CALIFORNIA REGIONAL WATER QUALITY CONTROL BOARD

ORDER No. 90-105

AN ORDER PRESCRIBING SITE CLEANUP REQUIREMENTS AND
RESCINDING ORDER No. 89-064 FOR:

INTEL CORPORATION
INTEL SANTA CLARA 3 FACILITY
2800 NORTHWESTERN PARKWAY
SANTA CLARA
SANTA CLARA COUNTY

Figure 6 Concentration of TCE vs. Time in Monitoring Well SC3-1 and Extraction Wells SC3-E1 and E2.

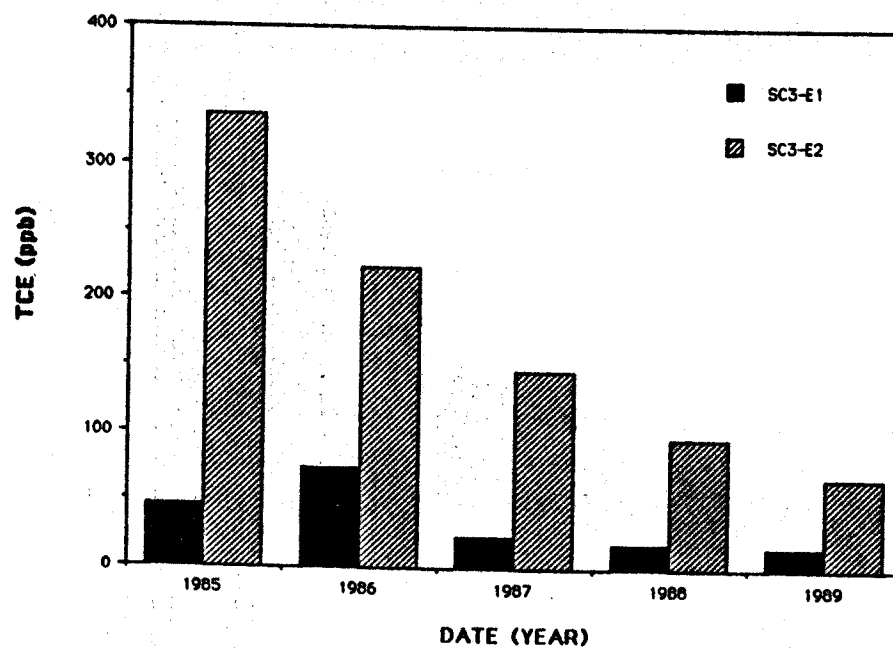
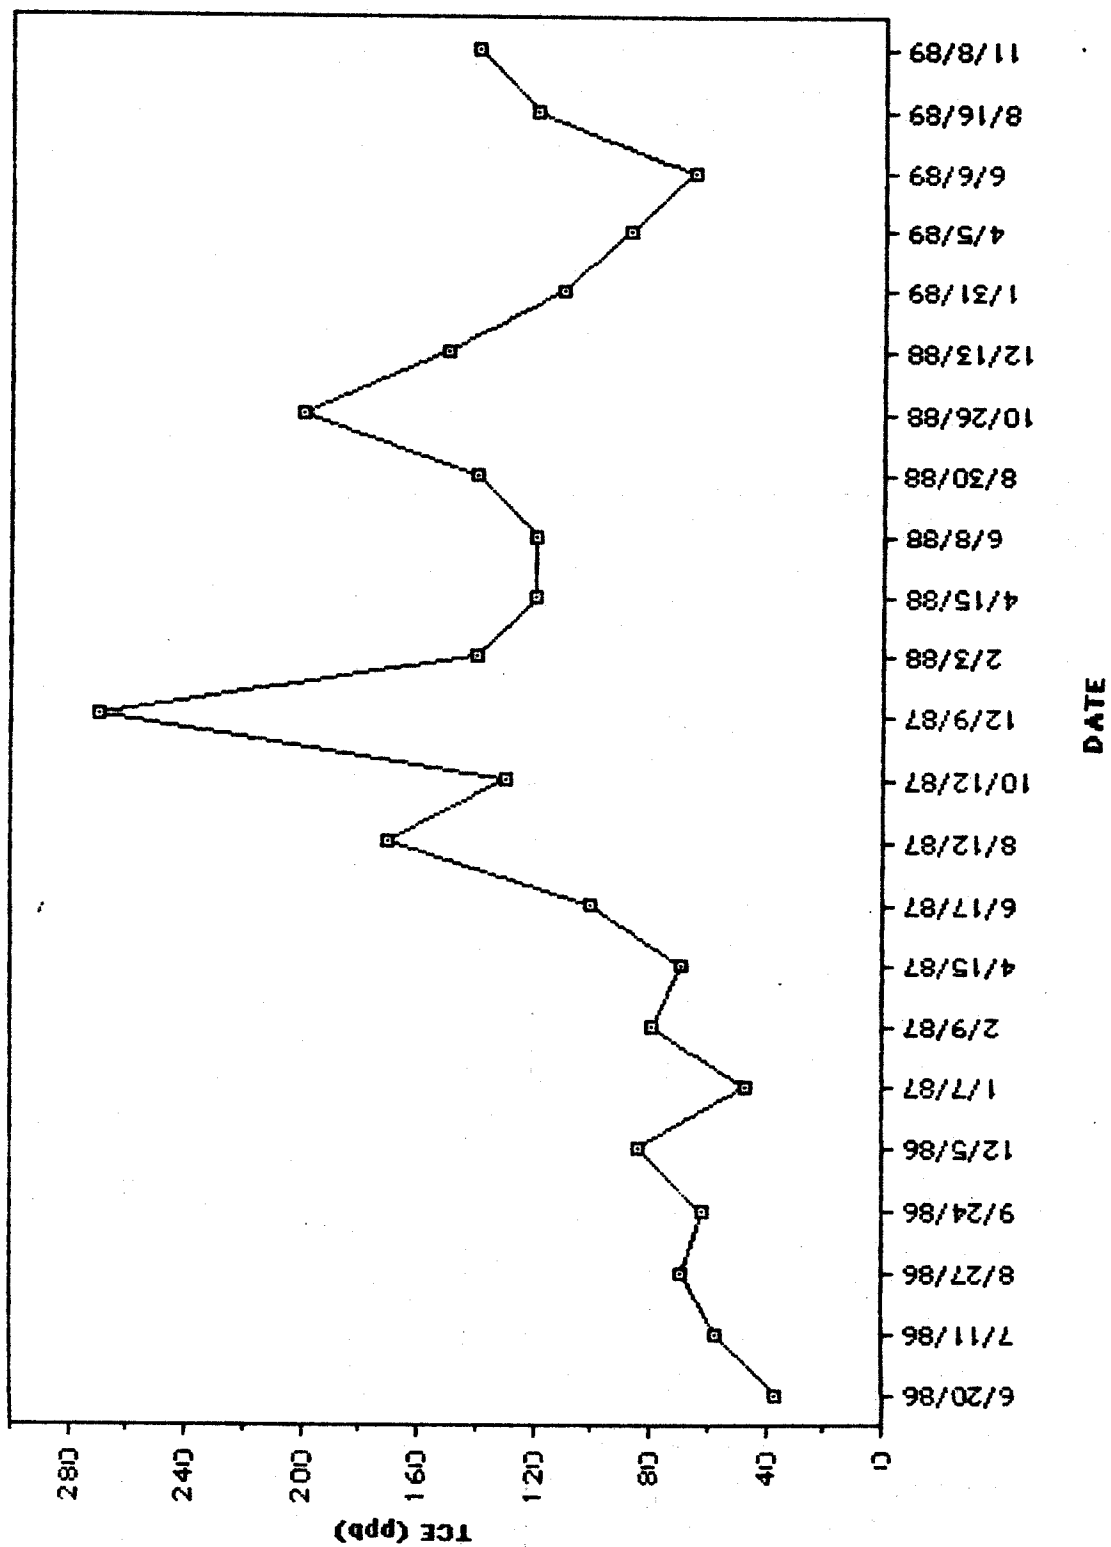
However, as shown on Figures 6 and 7 of the March 30, 1990 Staff Report (revised June 19, 1990), asymptotic levels do not appear to have been conclusively reached in all wells at SC3. With the installation of an additional extraction well and pulsed pumping, TCE levels are likely to decrease.
